Council Assessment Panel Agenda & Reports

17 March 2025

LODGEMENT DATE:	26 Sept 2024
RELEVANT AUTHORITY:	Assessment panel/Assessment manager at City of Norwood, Payneham & St Peters
PLANNING & DESIGN CODE VERSION:	P&D Code (in effect) Version 2024.17 12/9/2024
CATEGORY OF DEVELOPMENT:	Code Assessed - Performance Assessed
NOTIFICATION:	Yes
RECOMMENDING OFFICER:	Kieran Fairbrother, Senior Urban Planner
REFERRALS STATUTORY:	Nil
REFERRALS NON-STATUTORY:	David Brown, Heritage Advisor Matthew Cole, City Arborist

SHADOW DIAGRAM - 9AM SCALE: 1:200

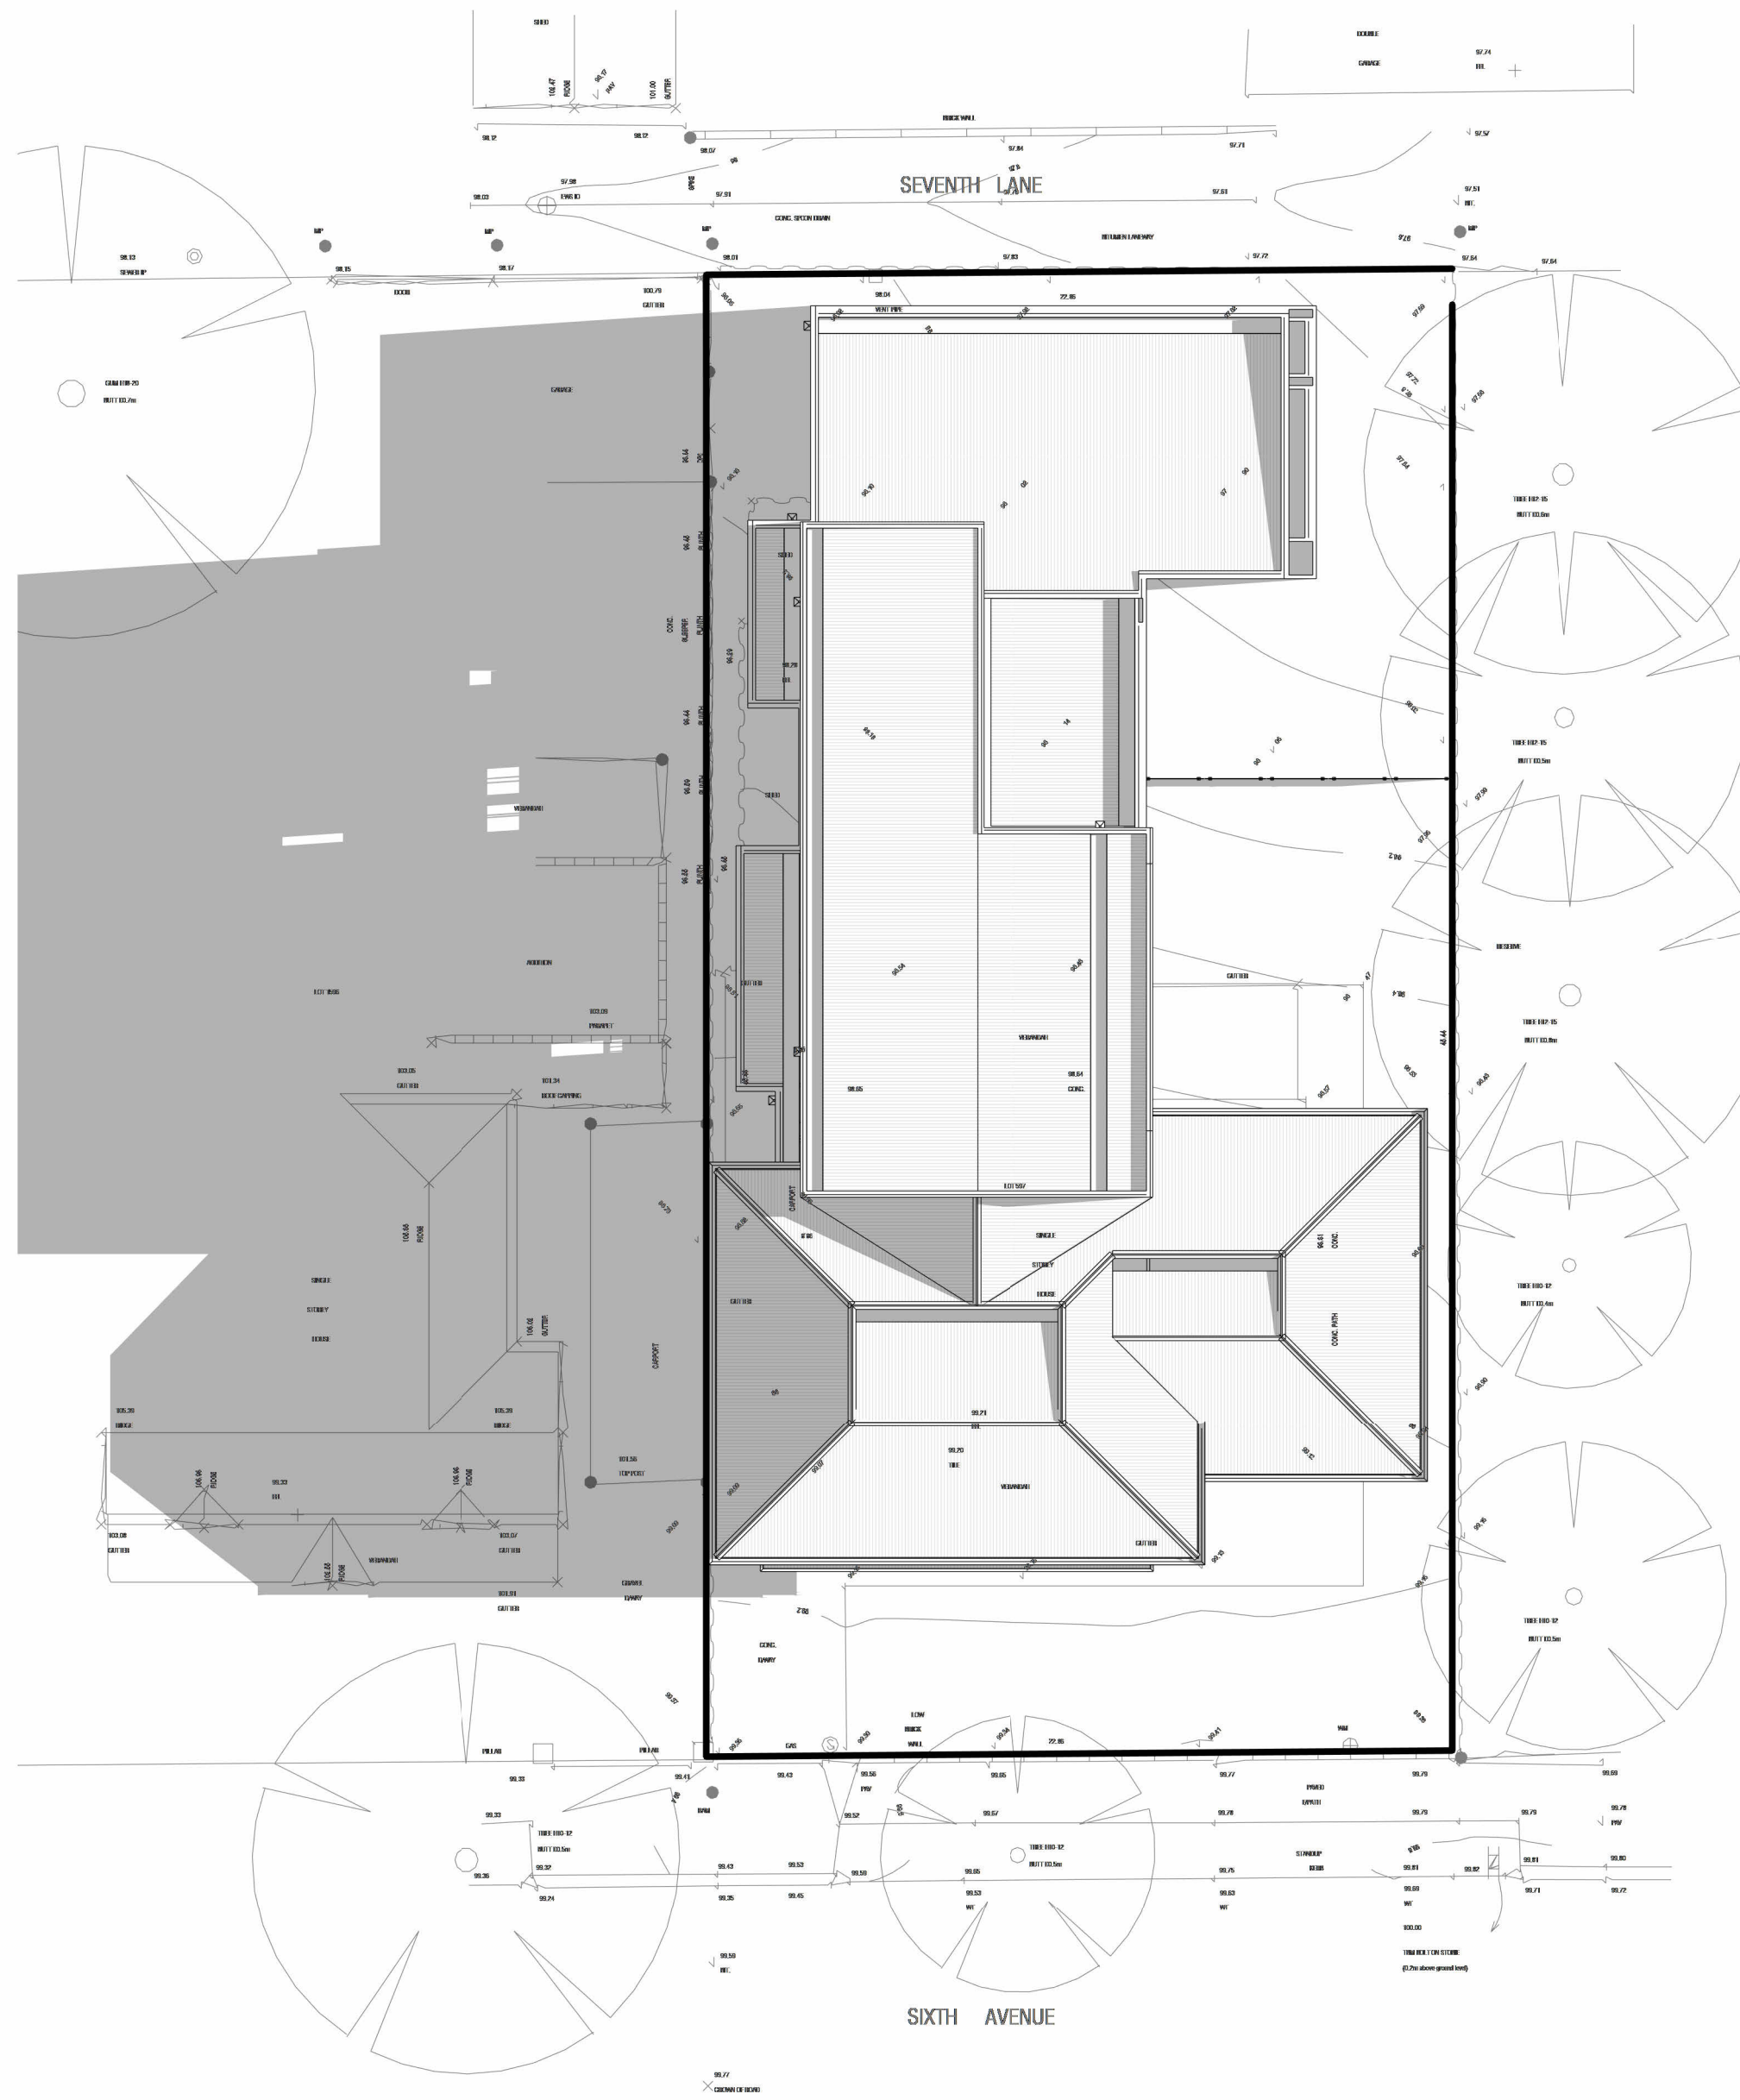
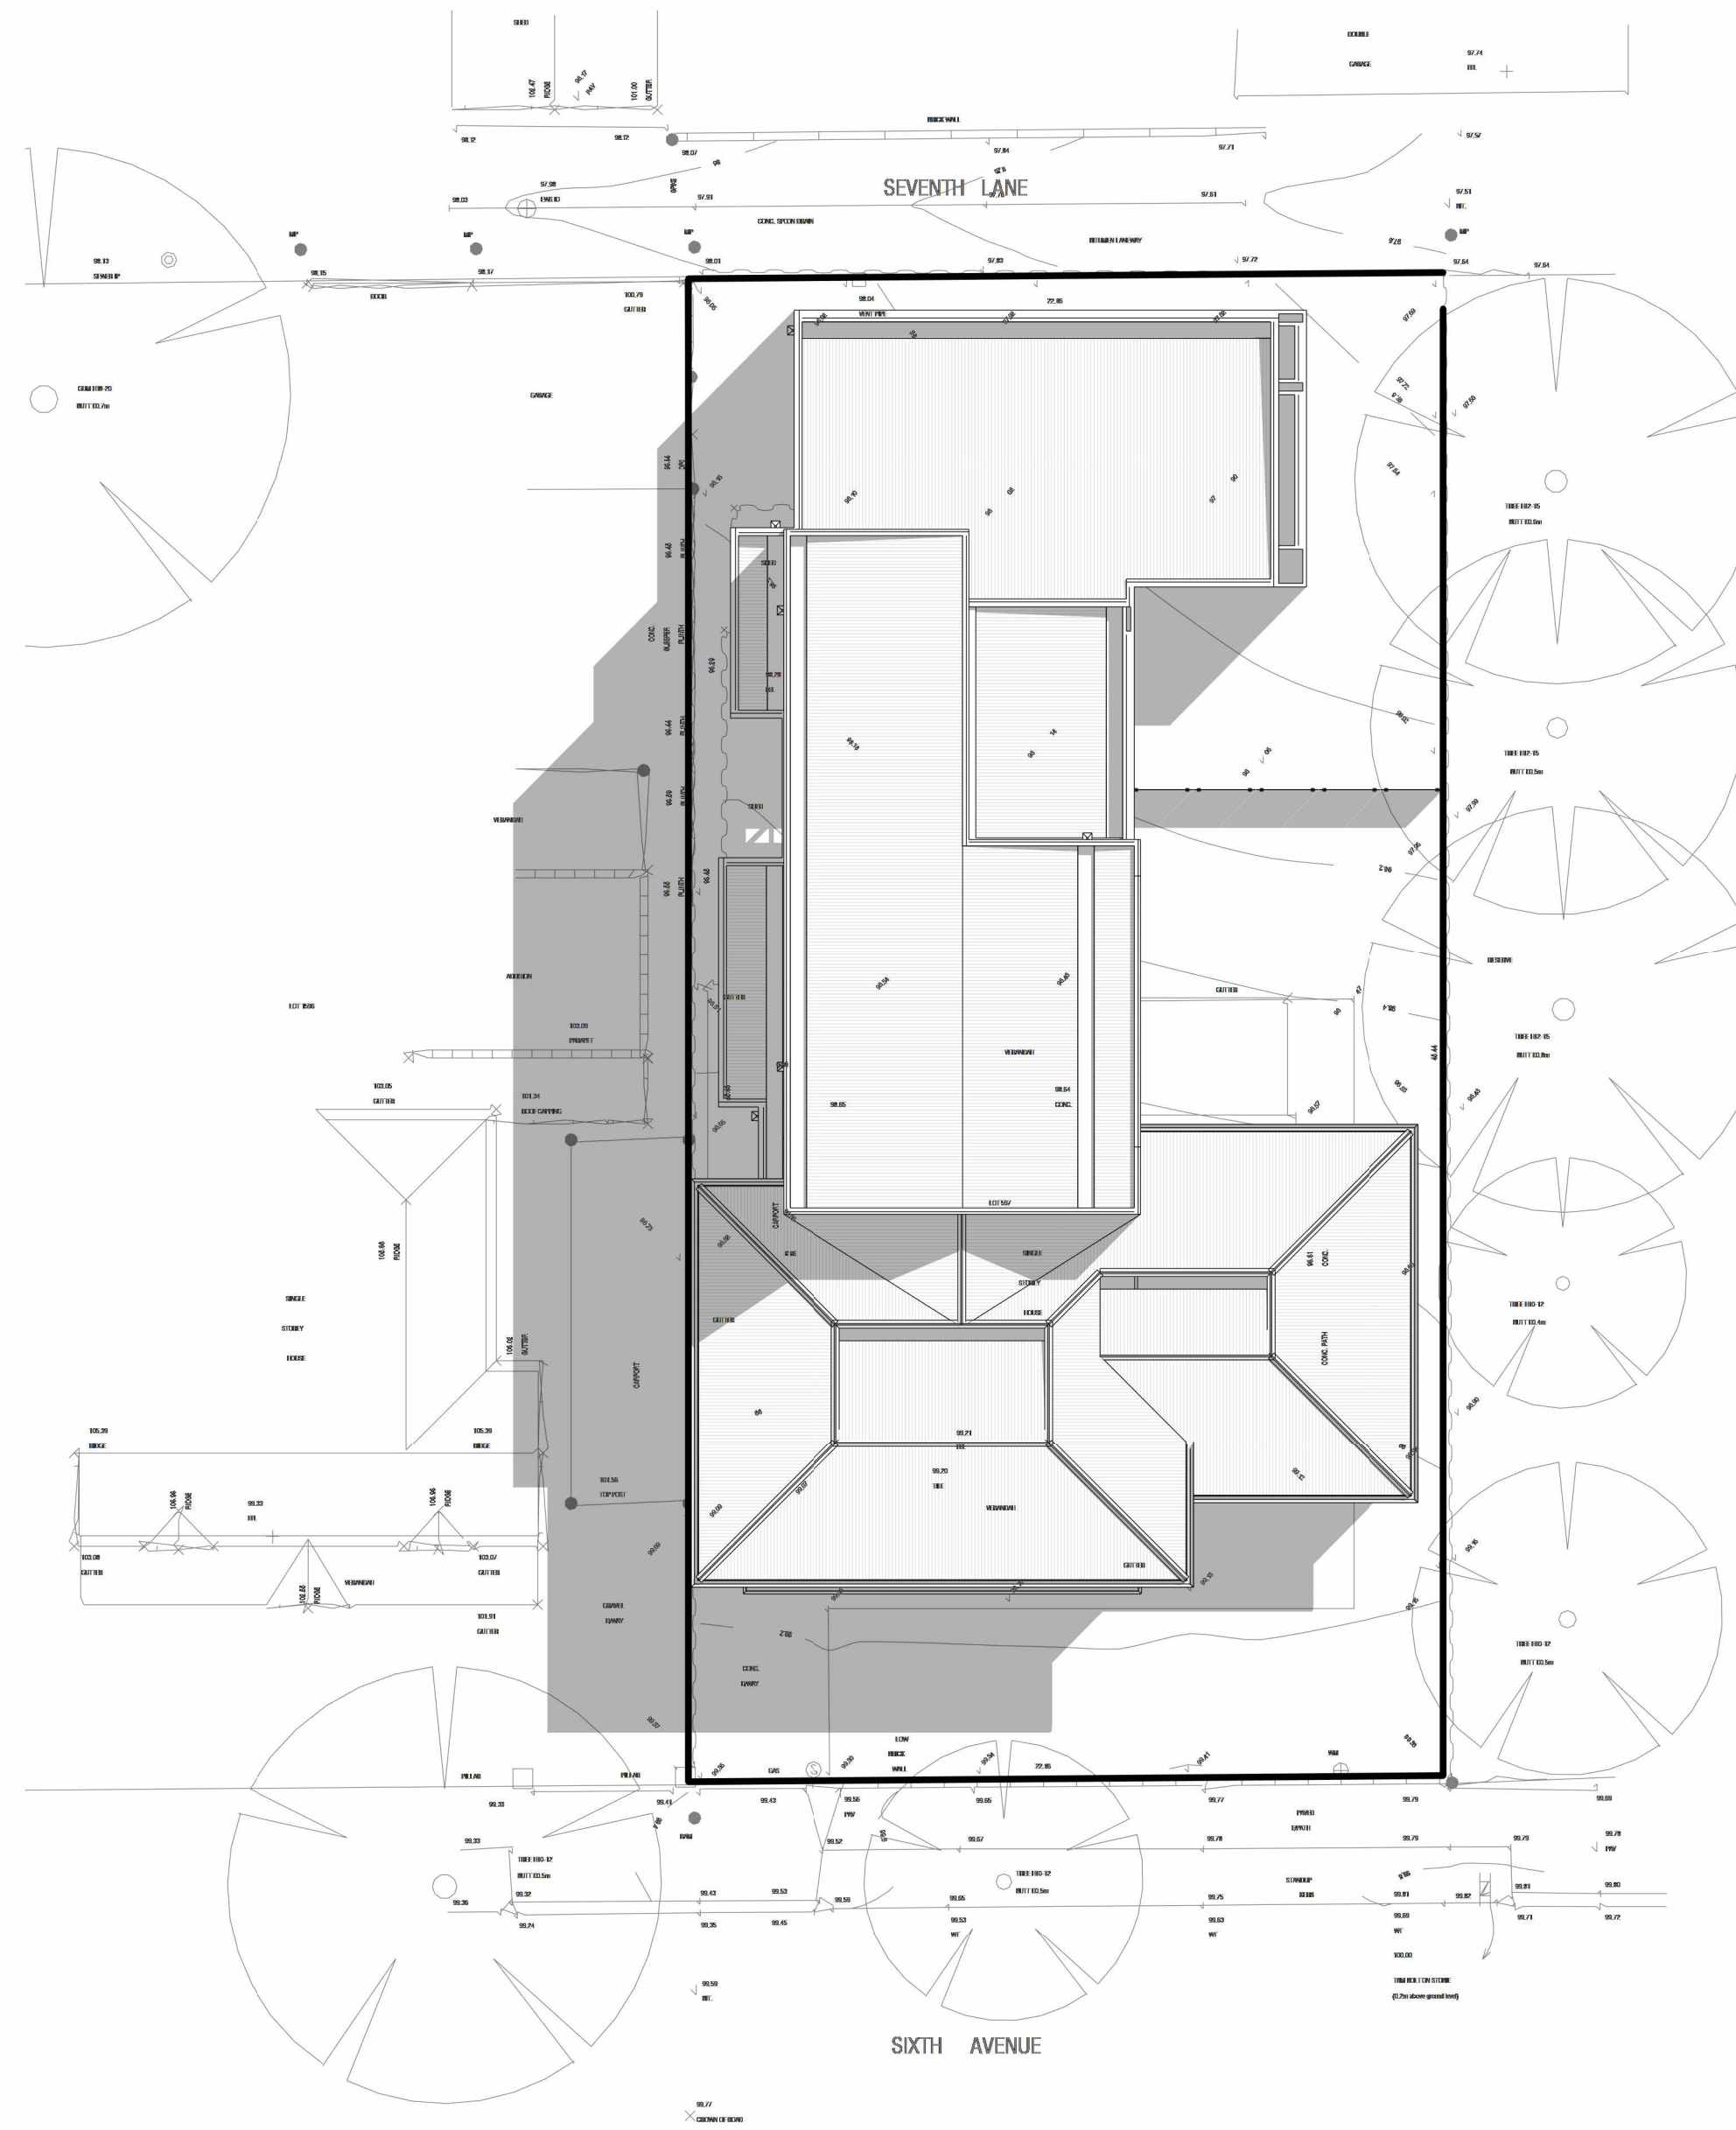
The adjacent dwelling at 46 Sixth Avenue has solar panels on the roof of their flat roof rear addition that will be impacted by the proposed development, as demonstrated by the shadow diagrams provided by the applicant (**Attachment 1**). These panels will be mostly shadowed during the morning period of the winter solstice, where one might expect the panels to have their lowest generating capacity because of the typically lower levels of sunlight. By the early afternoon of the winter solstice, however, the development does not provide any shadowing of these solar panels due to the northwest-southeast orientation of the two allotments. By inference, these solar panels will be largely unaffected by this development during summer, spring and autumn, when they have a larger generating capacity, because of the sun's higher angle in the sky. Accordingly, the development is considered to sufficiently accord with Performance Outcome 3.3 above.
